HISTORIC AND DESIGN REVIEW COMMISSION

HDRC CASE NO: 2019-044
ADDRESS: 829 N PINE ST
LEGAL DESCRIPTION: NCB 540 BLK 11 LOT A ARB A2
ZONING: R-5, H
CITY COUNCIL DIST.: 2
DISTRICT: Dignowity Hill Historic District
APPLICANT: David Flores
OWNER: David Flores
TYPE OF WORK: Install rear yard fencing
APPLICATION RECEIVED: January 09, 2019
60-DAY REVIEW: March 08, 2019

REQUEST:

The applicant is requesting a Certificate of Appropriateness for approval to replace the existing rear and side yard chain-link fence with the new metal-framed cattle panel fence at 5 feet tall.

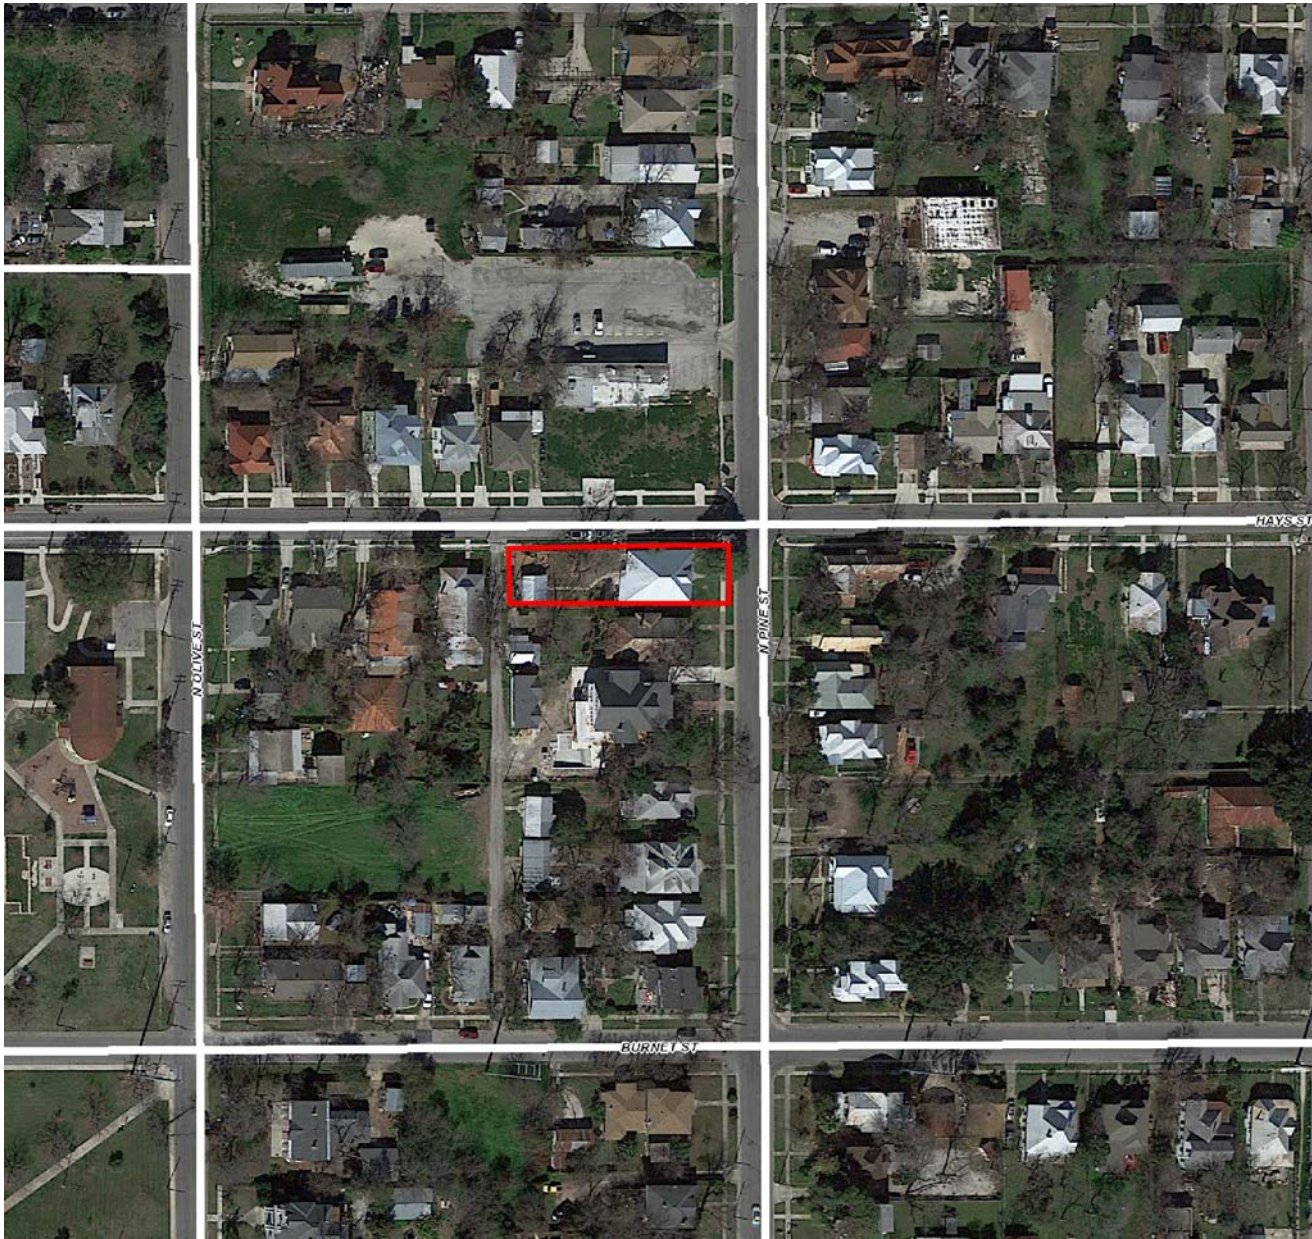
Staff recommends approval to replace the rear chain-link fence with metal-framed cattle panel fencing based on findings b and c with the following stipulations:

- i. That no portion of the fence exceeds 5 feet in height, nor encroach beyond the front façade plane of the primary historic structure.
- ii. That plant growth over the fence be reintroduced to the new fence to minimize its visual impact.
